GOVERNMENT AIRCRAFT FACTORIES

In Reply Quote S/B NMD-39-1
Revision 1

SUBJECT: NOMAD SERVICE BULLETIN NMD-39-1 - REVISION 1

SUBJECT: AIRSPEED INDICATOR MODIFICATION TO DIAL MARKINGS

ASI FOR N22 PART N° 1/N-80-442 OR EA-5173-(5)-GAF

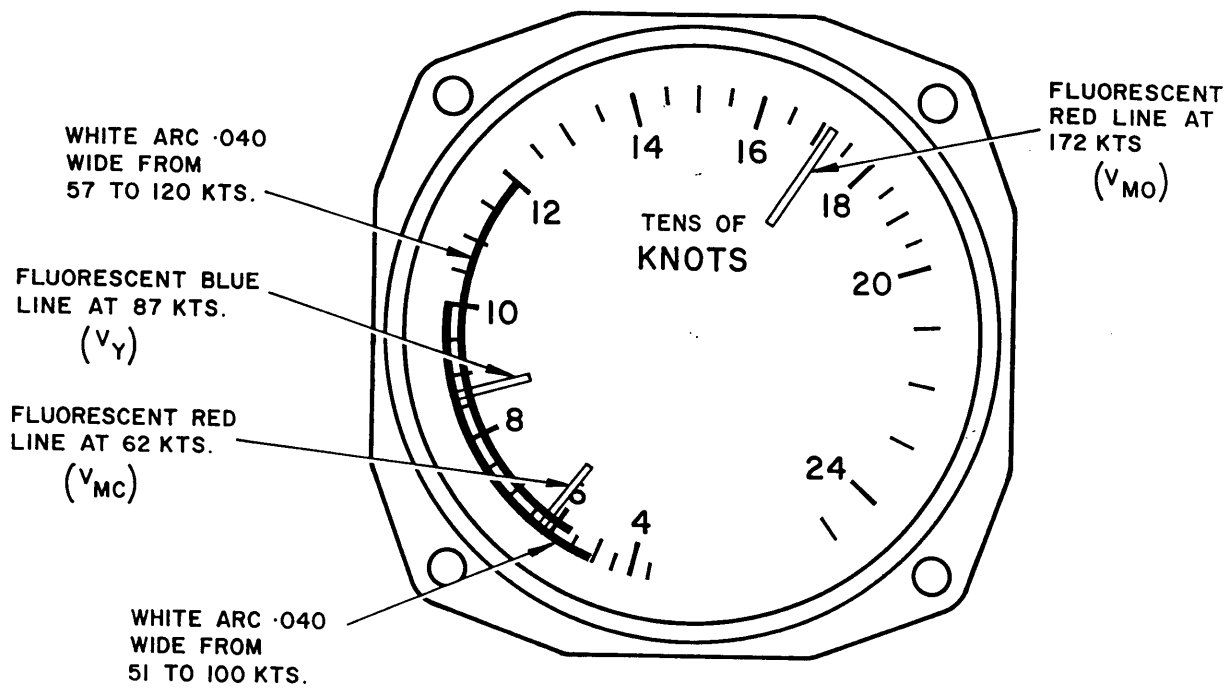
(10) Page 6, Figure 1

Part No EA-5173(4)-GAF now reads EA-5173-(5)-GAF

"Dial Part No 1A/N-80-442" deleted.

Replace with the new, overhauled, repaired or reworked unit which has dial markings conforming to Figure 1. Replacement unit is identified by P/No. 1/N-80-442 or EA-5173-(5)-GAF.

ASI FOR N22B PART N° 2/N-80-442 OR EA-5173-(6)-GAF

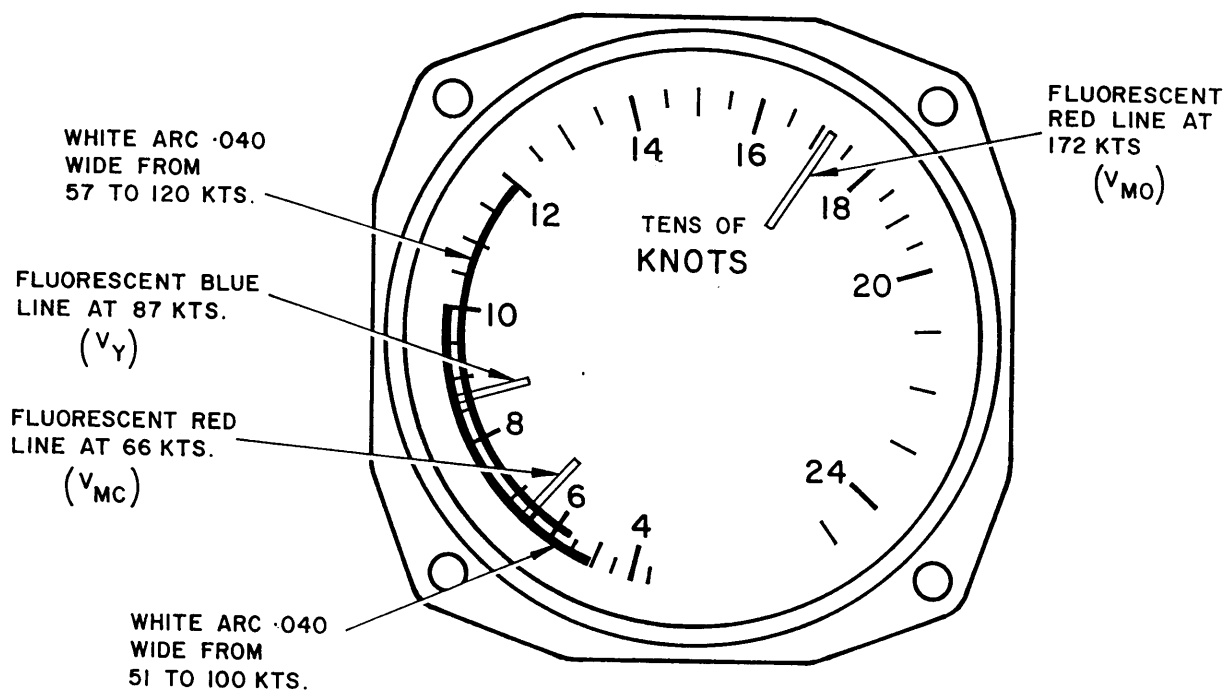
(11) Page 6, Figure 2

Part No EA-5173(5)GAF now reads EA-5173-(6)-GAF

"Dial Part No 2A/N-80-442" deleted.

Replace with the new, overhauled, repaired or reworked unit which has dial markings conforming to Figure 2. The replacement unit is identified by P/No. 2/N-80-442 or EA-5173-(6)-GAF.

FIG. 3
VMO PLACARD
AFFIXED AS SHOWN
(RH PANEL SIMILAR)

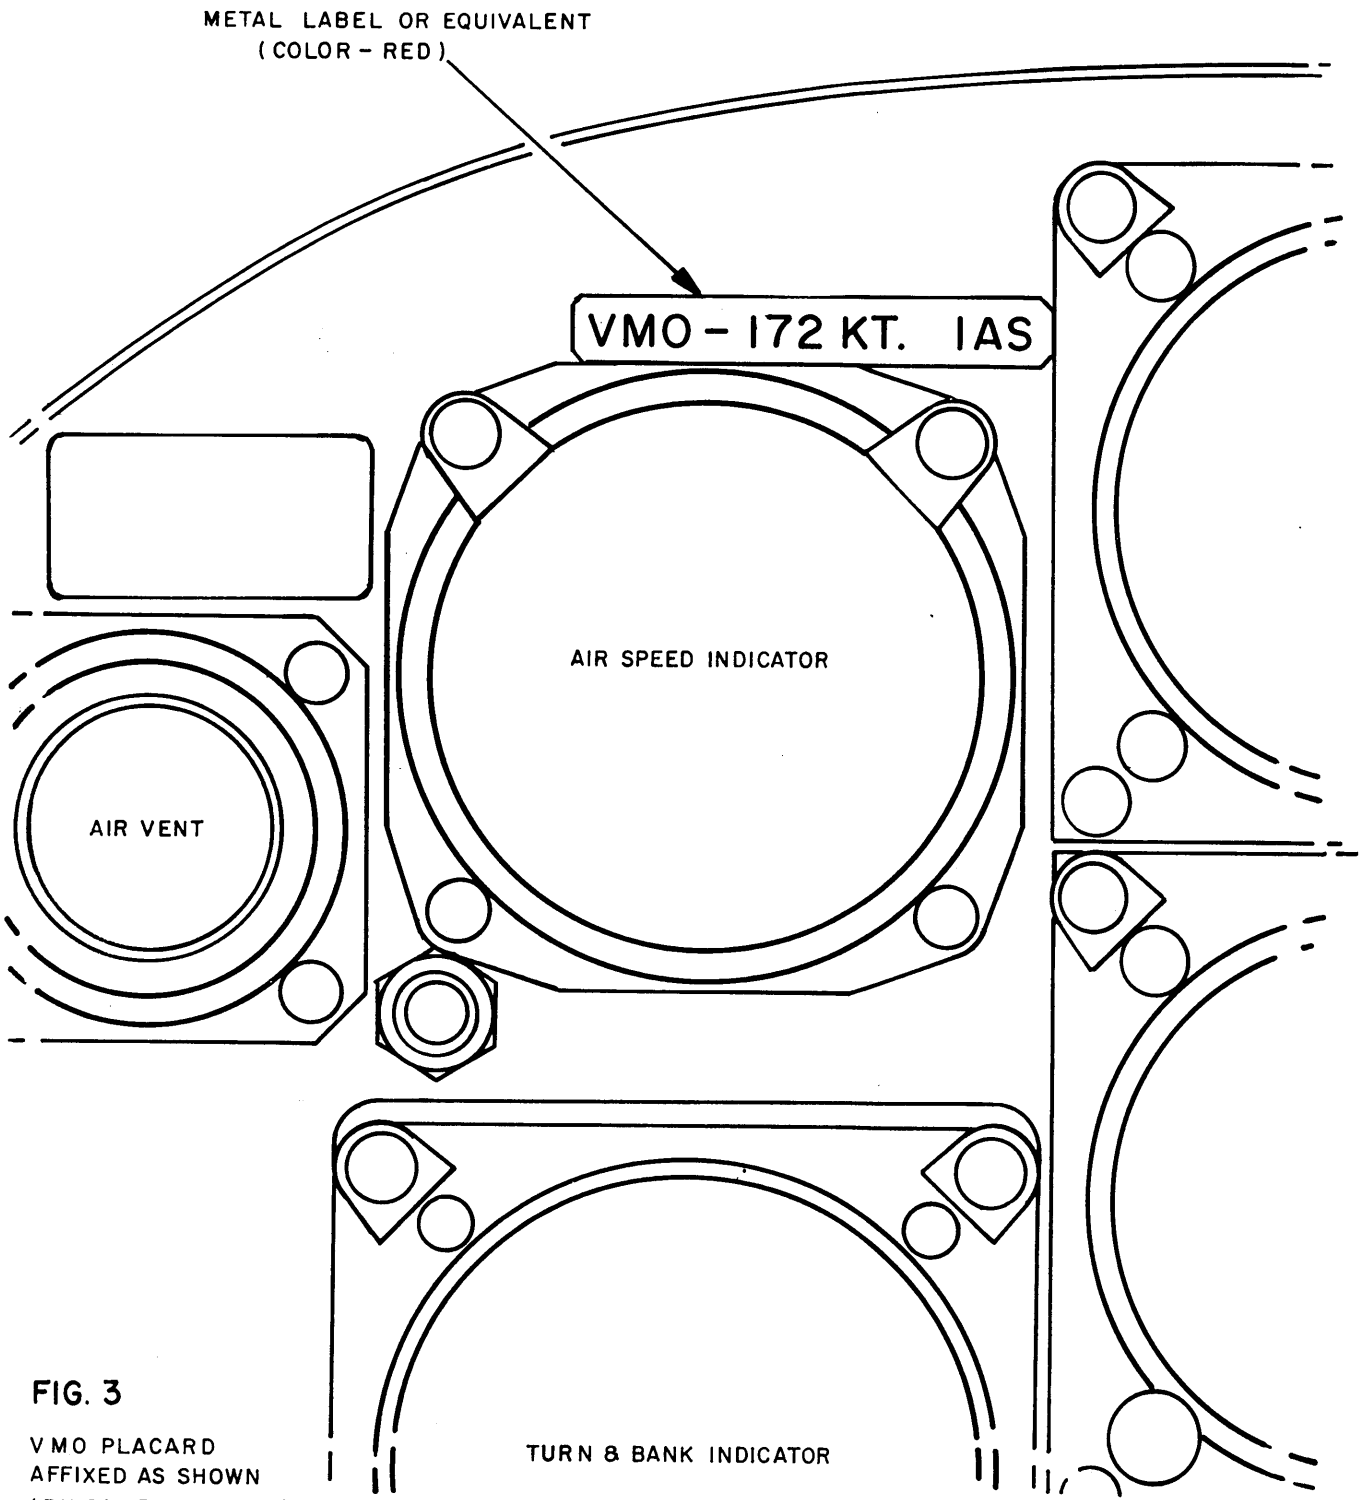
- (i) Affix a placard with the caption as per Figure 3 adjacent to the L.H. ASI in location shown.
- (ii) When optional R.H. ASI fitted affix similar placard as item (i) above.

Part 1 Locally manufacture, as required, label from Metcal, scotchcal
(colour red) or suitable equivalent as per Figure 3.
